SUBJECT Response to Request for More Information
Derry-Londonderry, 13065
DES File #2018-03134

RESPONSE TO NHDES REQUEST FOR MORE INFORMATION
NHDES # 2018-03134

TROLLEY CAR LANE STREAM RELOCATION
LONDONDERRY, NEW HAMPSHIRE

RESPONSE TO NHDES REQUEST FOR MORE INFORMATION
NHDES # 2018-03134

Figure 1. Trolley Car Lane stream (S1) survey locations and segment classification

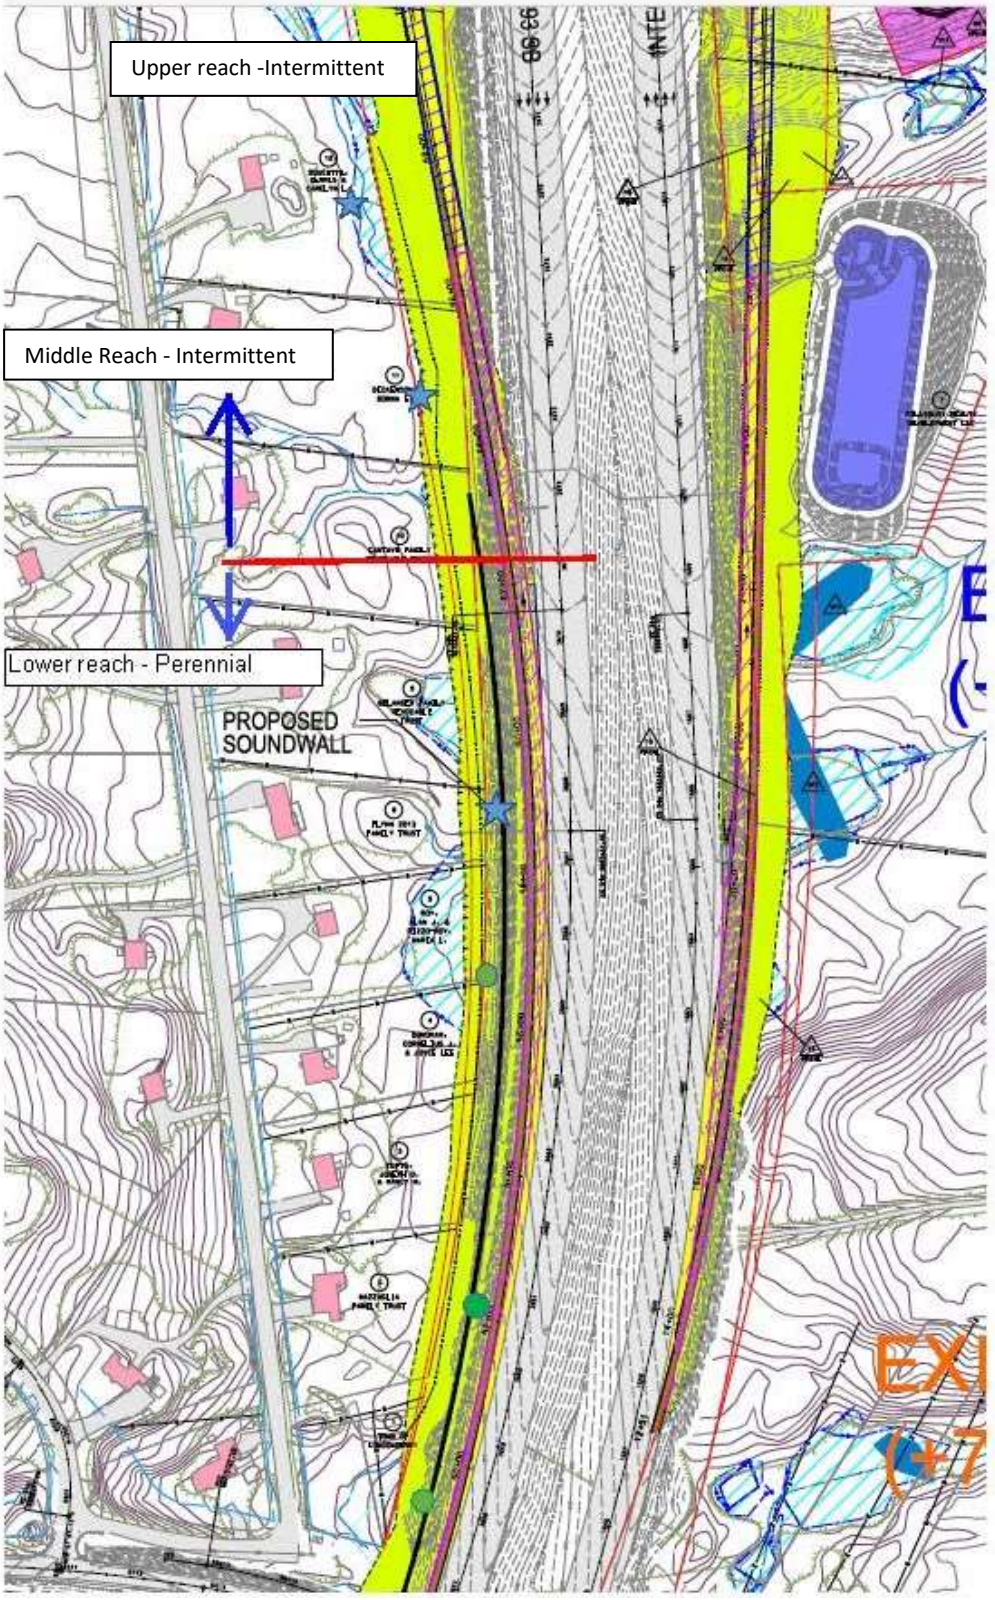
This agreement is also dependent on **stream restoration design and plans**, which are being submitted with this RFMI response. NHDES has requested that the stream channel reconstruction design address the following elements:

In Figure 1, the blue stars represent approximate locations of the Normandeau stations associated with the upper, lower and middle reaches where metrics in Table 3-1 were recorded (in 2010). The Middle Intermittent Reach data in Table 3-1 was collected from the intermittent reach that must be relocated. (The Upper Reach in Table 3-1 shown at the upper blue star is upstream and outside of the impact area). The Lower Perennial reach data was collected from the perennial segment that will be relocated.

It should be noted that for simplicity of modeling and construction, the delineation between the middle intermittent and lower perennial portion of the stream for the proposed hydraulic and channel design was based on the change in water surface slope of the channel rather than the location identified on Figure 1.

Map 1. Diagram showing locations of the cross sections (red lines), vegetation plots (orange boxes) within the monitoring reach at Trolley Car Lane Stream, Londonderry, New Hampshire.

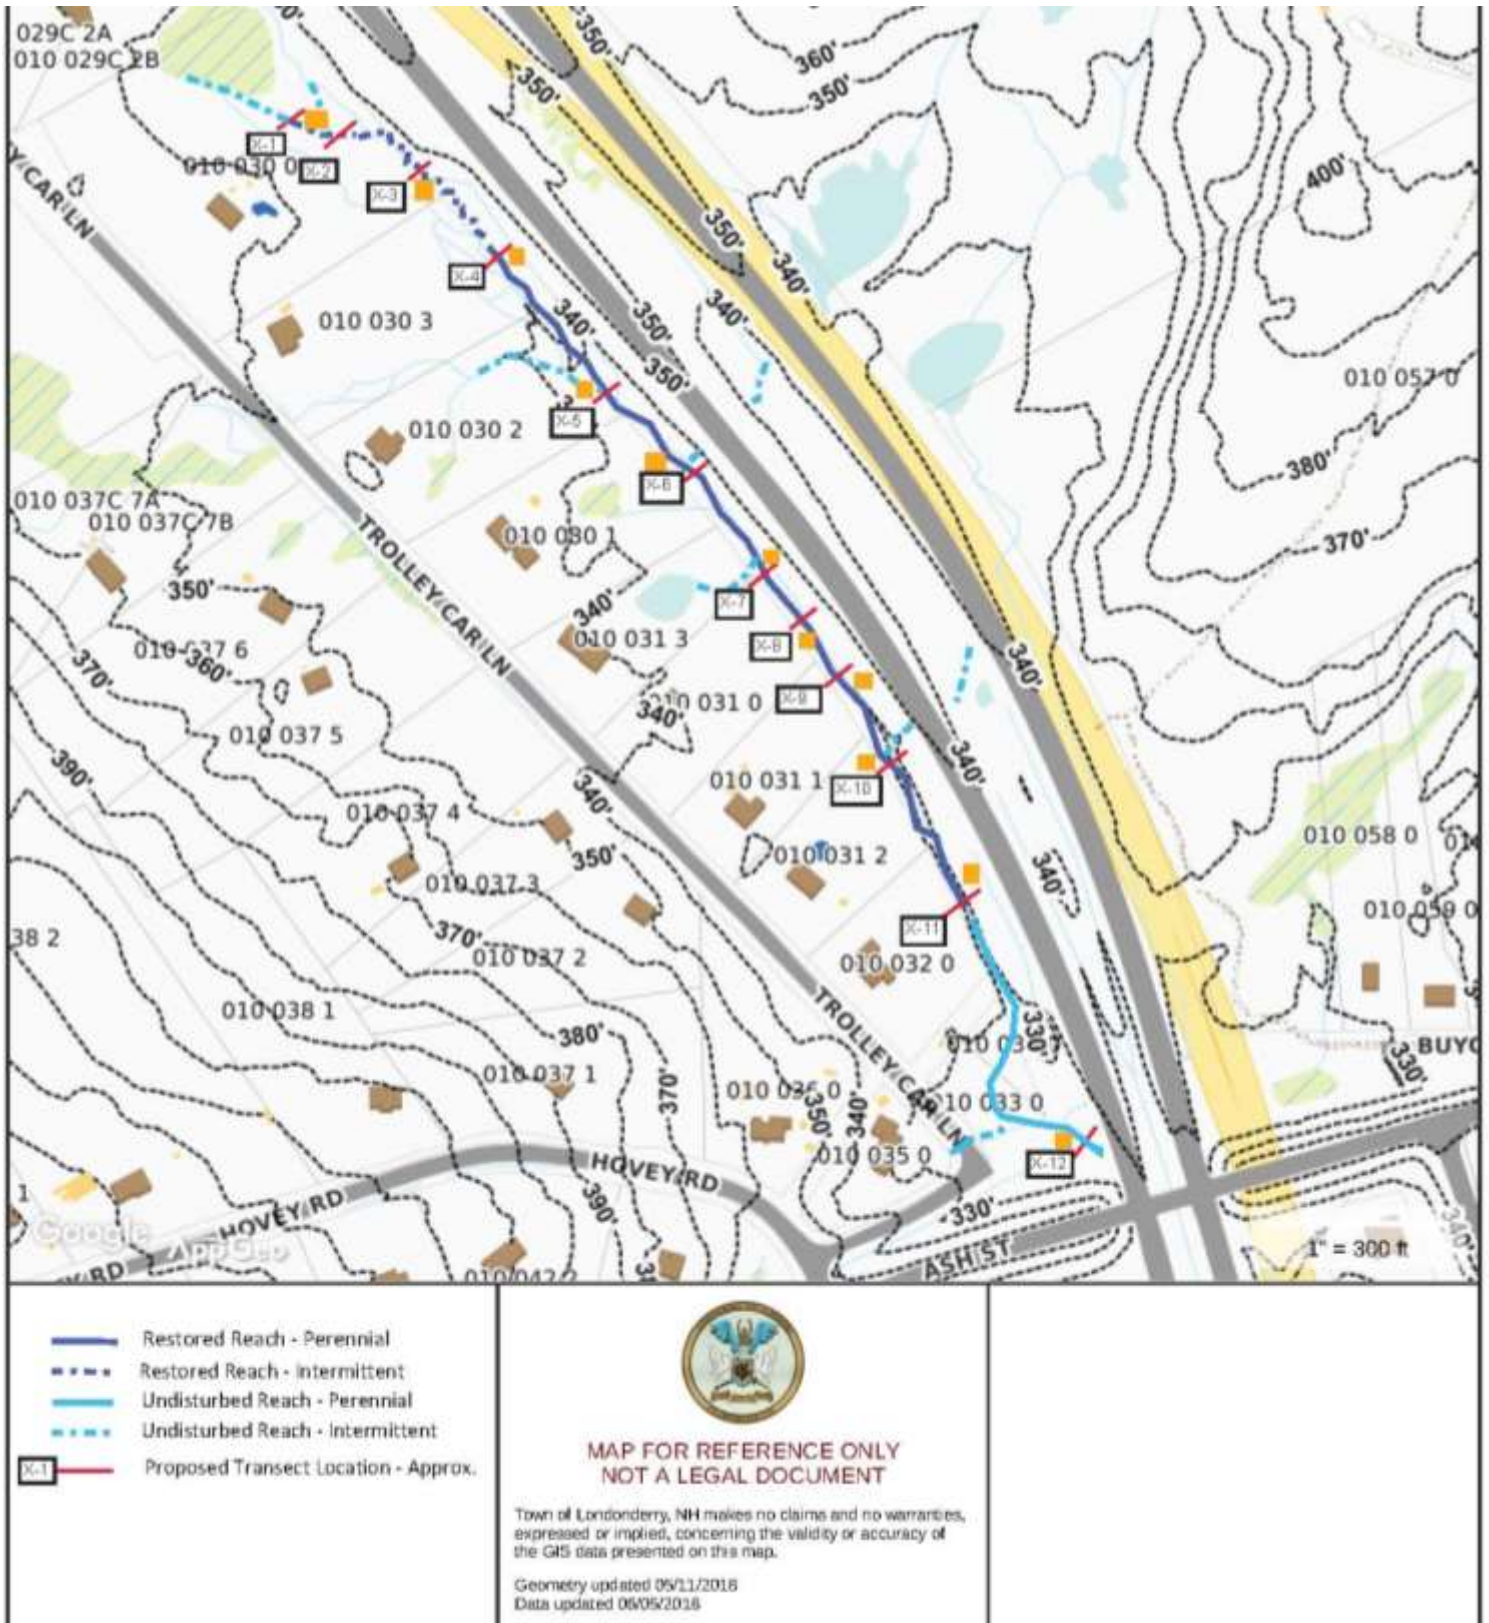
NHDES has also requested a Trolley Car Lane **Stream Restoration/Re-establishment Monitoring Plan**.

The monitored cross sections were selected based on the engineers designed grade controls in the existing plan set. These locations will be used together to provide information on the project restoration's goal of a stable channel elevation in the restored reach. The cross-sections will be georeferenced (post-construction), flagged, and mapped for monitoring consistency (Map 1). Several of the monitoring parameters, such as sediment distribution, photo stations, and longitudinal profile data, will be evaluated at each cross-section for long-term observations of change. Once established, these cross-section locations will not change. Preliminary visual assessments will be made prior to initiating construction and use of spatial imaging (such as LiDAR or aerial photos) will be used to aid in long term review of the channel changes. Channel and bank features will be collected as part of the monitoring protocol at established cross-sections. The following data will be observed and recorded: areas of aggradation, bed scour, bank erosion, and changes to installed structures (i.e. bioengineering materials, wood additions, rock weirs, grade control stones, and constructed step-pools). Cross-section measurements within the project reach will include floodplain width, bankfull width, wetted width, and water surface elevations/depths.

Photos should be taken from the **same locations** for each monitoring event and included on the site map. Take repeated photos at these locations: 1) all downstream gradient structures (rock weirs/vanes and step-pools, if designed), 2) across the stream channel from right bank to left bank at each cross section 3) views of the stream channel directly upstream 4) views of the stream channel directly downstream 4) erosion control structures and 9) areas of the floodplain where plantings were done. Photos may be included in an appendix, submitted as a separate file, or in the text to correspond with the data for each parameter.

TROLLEY CAR LANE STREAM PROFILE
 SCALE:
 1" = 50' HORIZ.
 1" = 10' VERT.

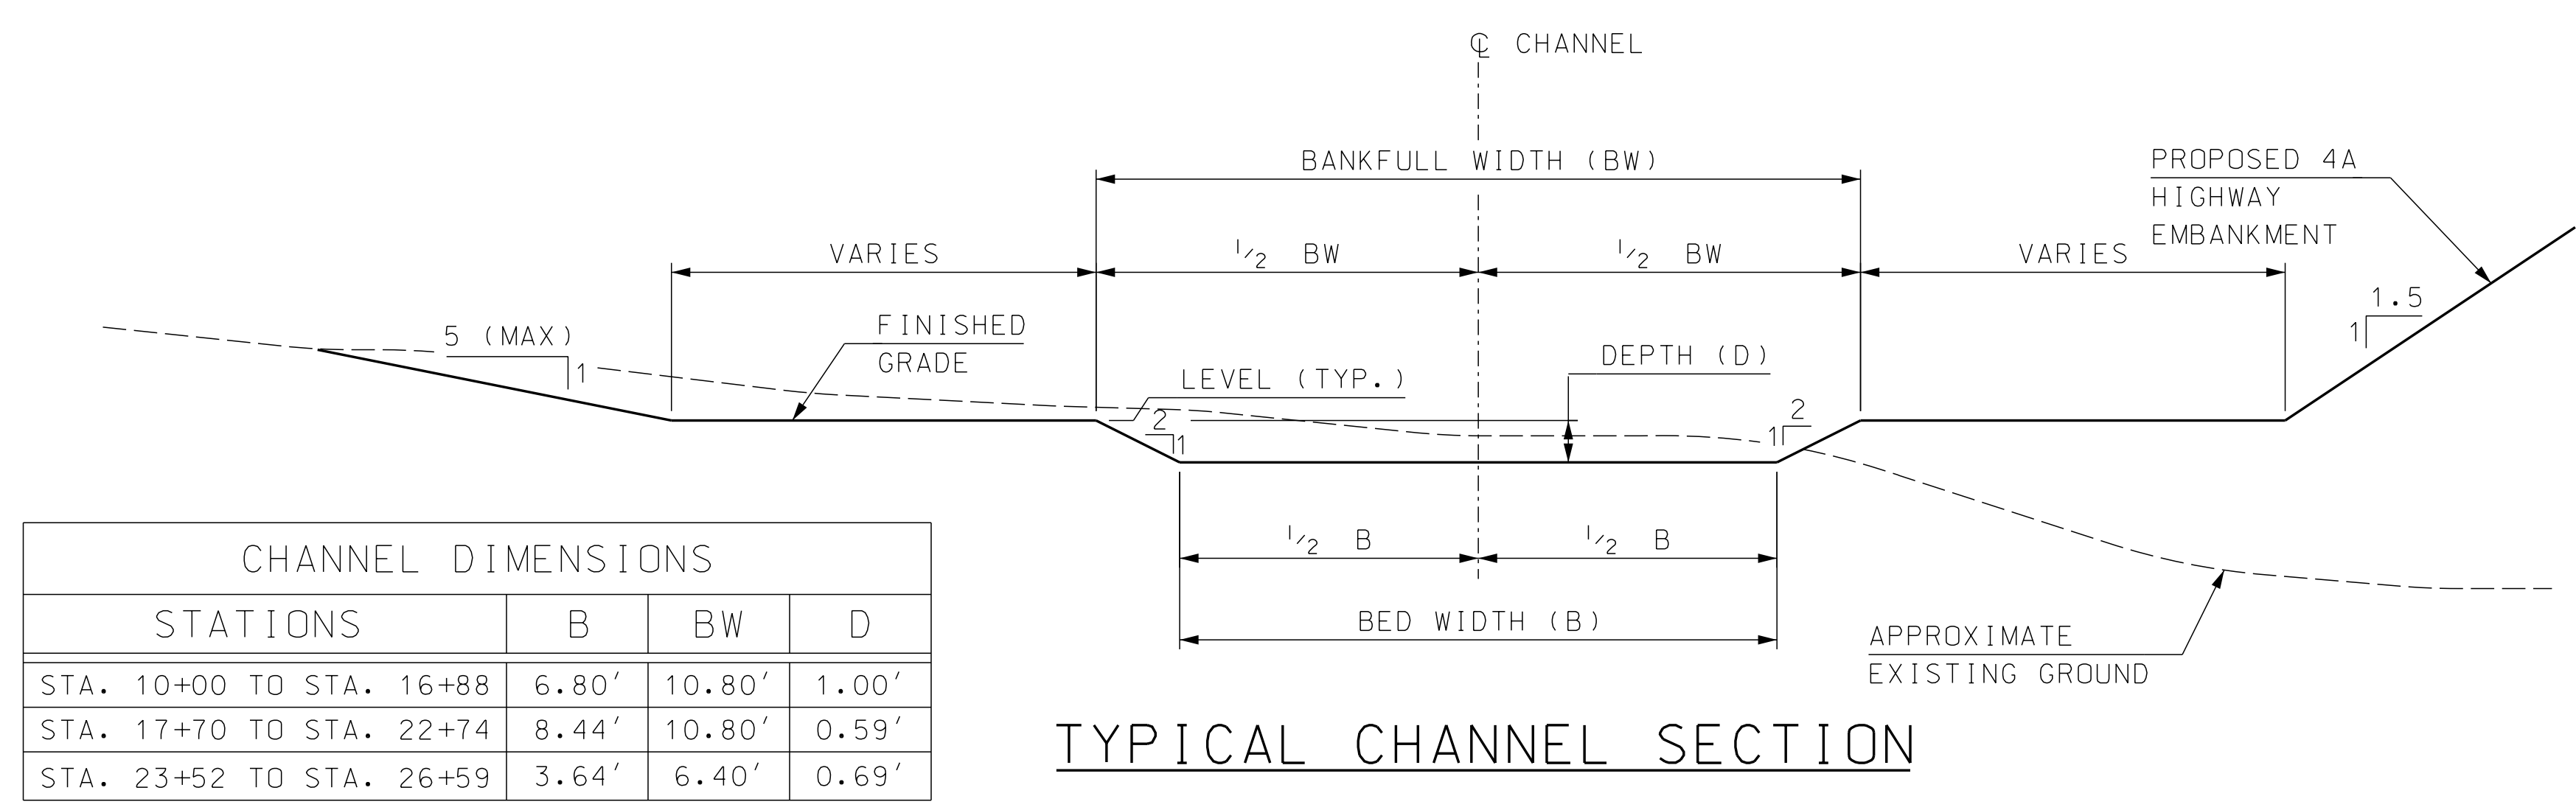
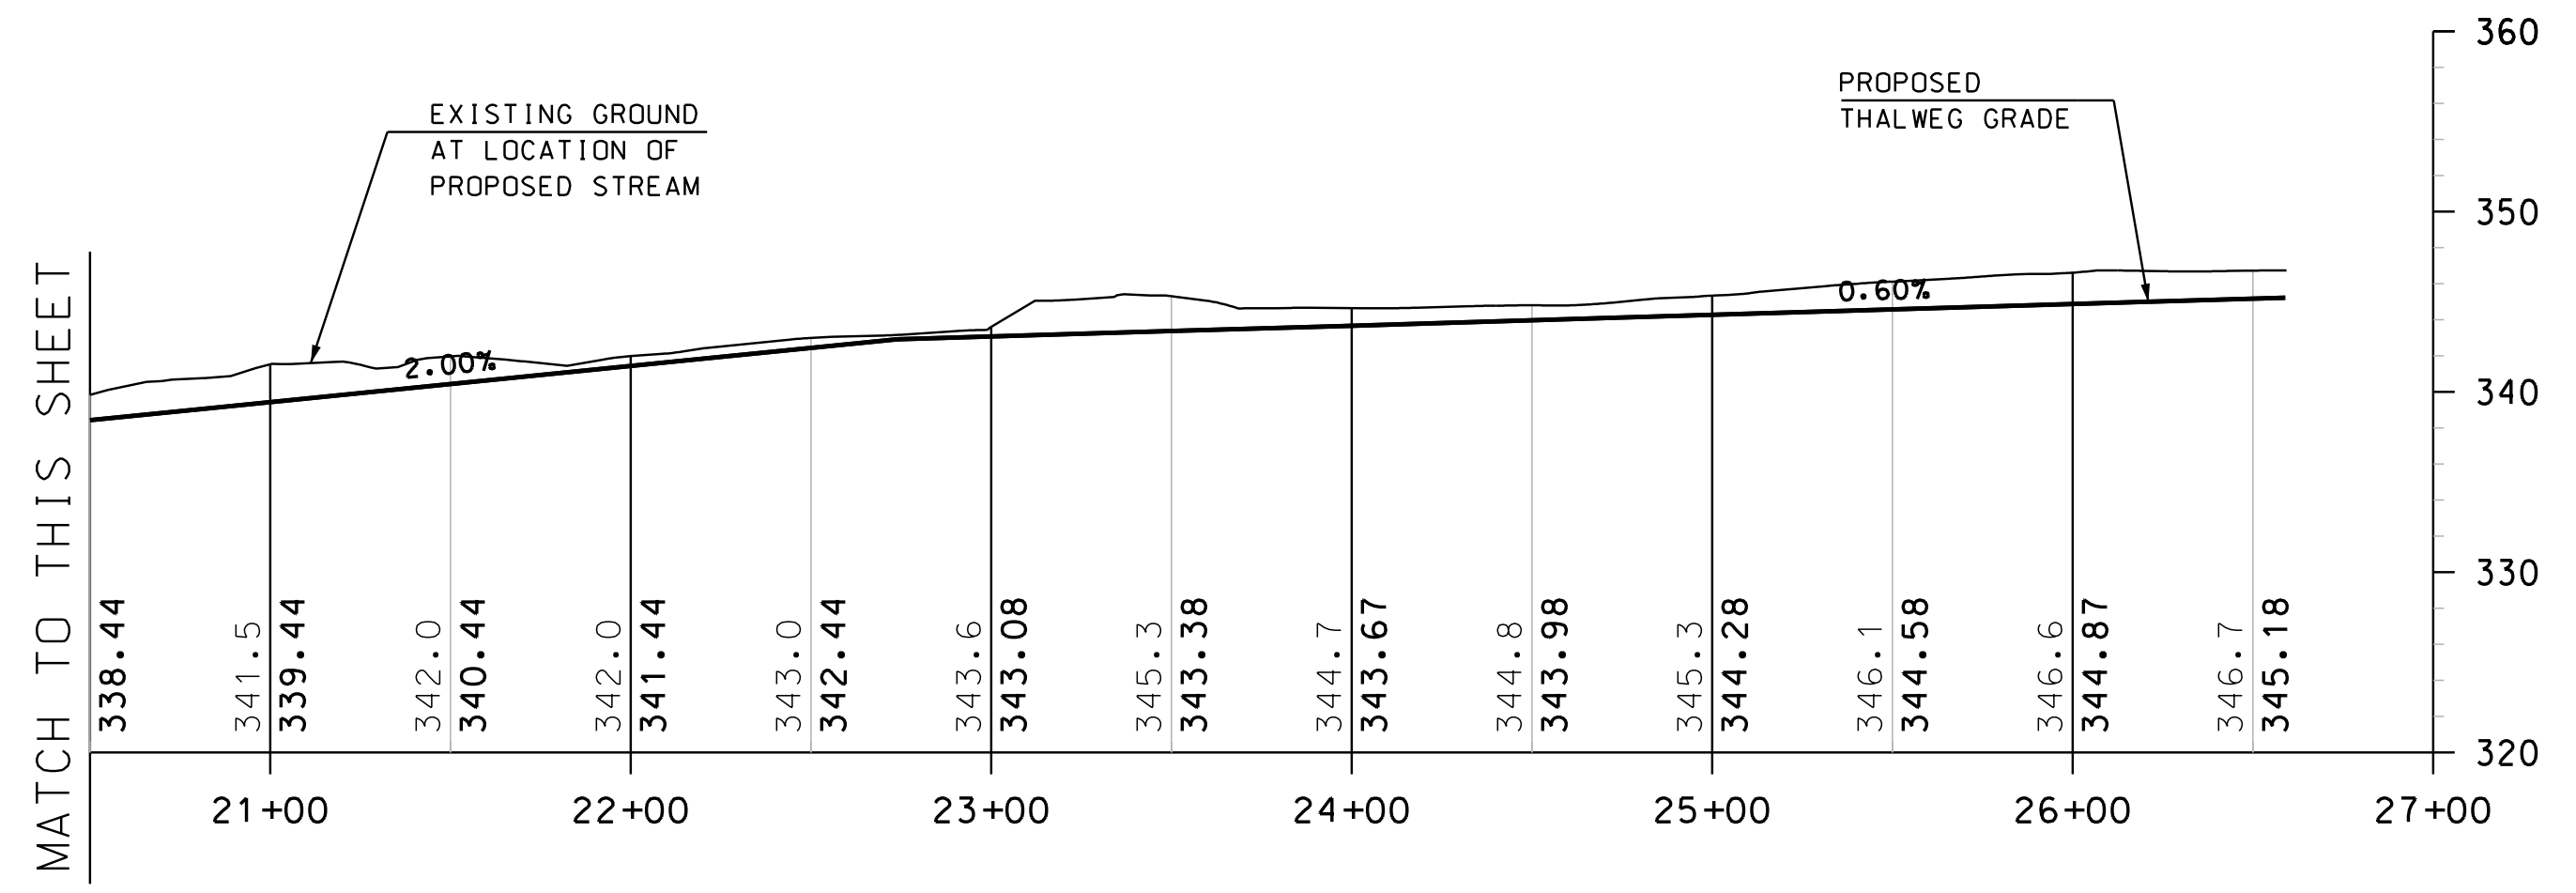
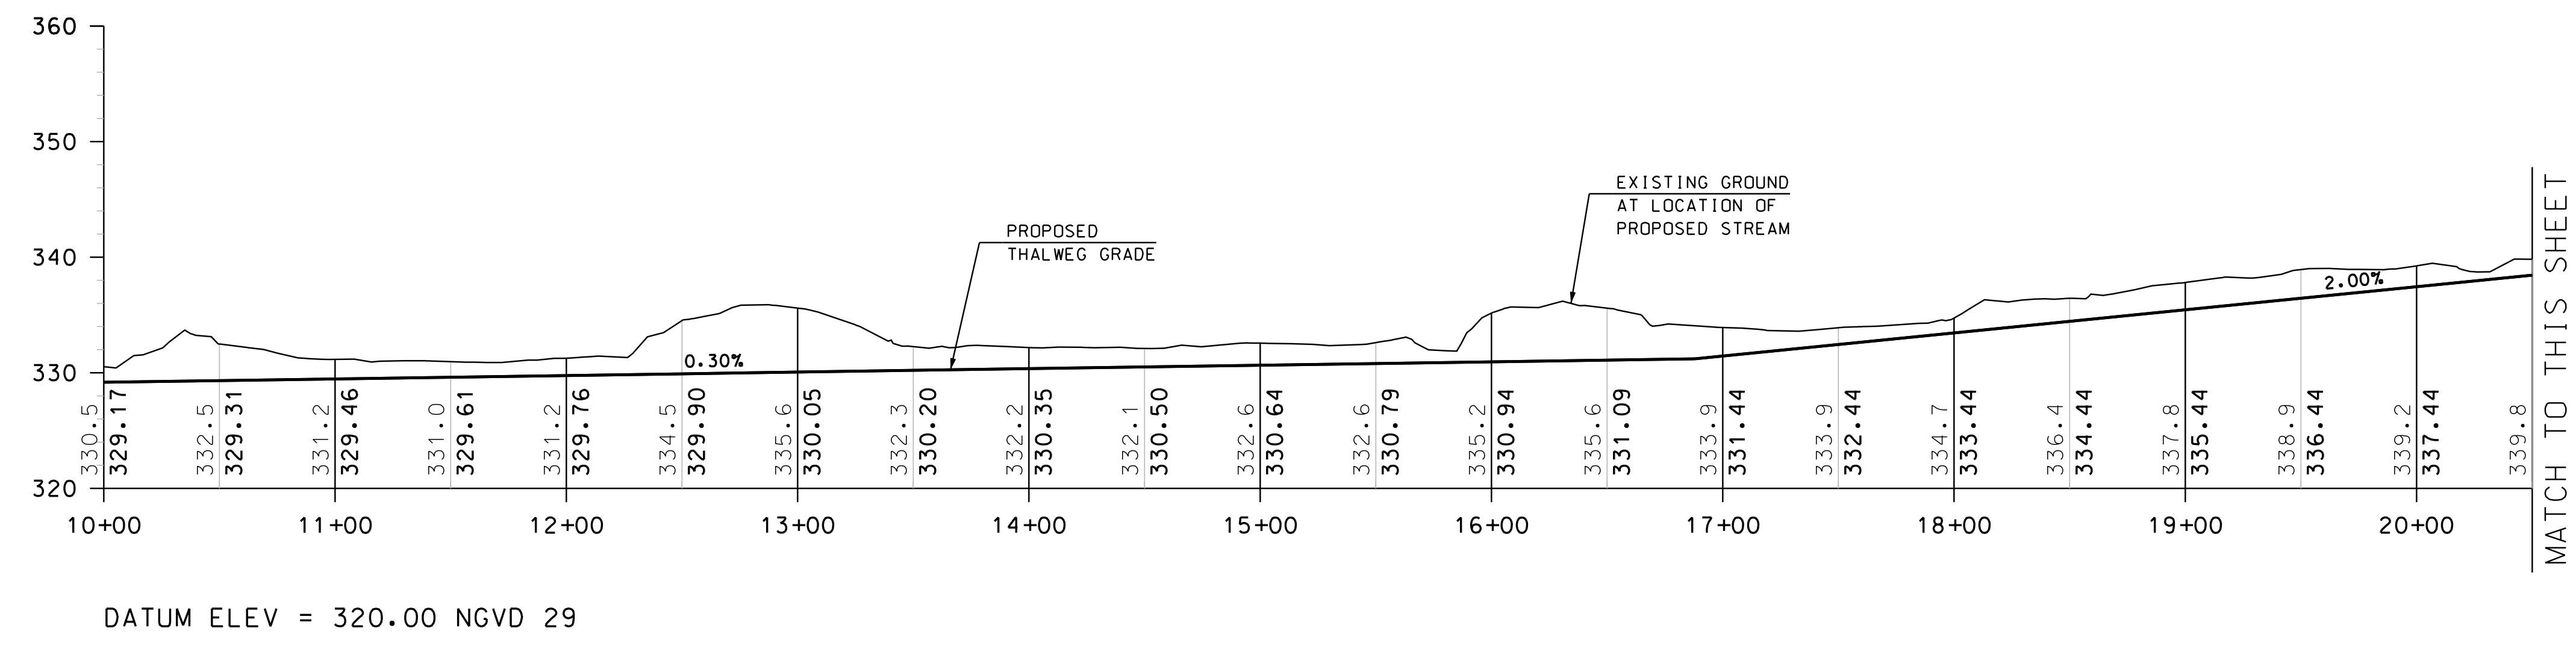
- Bank full width
- Entrenchment Ratio
- Sinuosity
- Net floodplain
- Existing forested buffer
- Native planting plan
- Stream bed simulation material
- Longitudinal profile and grading plan
- Accommodate perpendicular tributary flows to Trolley Car stream
- Accommodate for any increased flow volume due to additional impervious (BFW/ER)
- Methodology of stream reconstruction

A stream restoration grading plan, with relevant notes, is attached (**Attachment D**). The information requested by NHDES relevant to the stream relocation/restoration design are described below.

Grade control features within the new channel will be required within the limits of the Stream S1 observed riffle pool locations. Additional grade control features will be required at the slope change locations identified in Chart 1 above. These locations are identified on the grading plan, but extend from approximately Station 22+75 to 23+52 and Station 17+70 to 20+82 within in the middle intermittent reach, and from Station 11+64 to 13+62 and Station 10+00 to 10+50 within the lower reach outside the limits of the original study. The grade control features shall be cobble, log, or rock weirs, and shall extend approximately 6 inches above the riverbed elevation.

Riffles and pools should be established within the areas shown in the stream restoration grading plan in Attachment E. In the perennial section of the project, riffles make up approximately 56% of the reach, run is 20% and pools are 24%. Cobbles placed within the channel above stream curves can be used for creating riffle sections. If additional grade controls are needed within the stream channel, boulder/cobble weirs and/or logs embedded into the stream channel and banks can be used to create step pools. Materials salvaged from the construction area may be used for this purpose if they meet the material specifications on the grading plan.
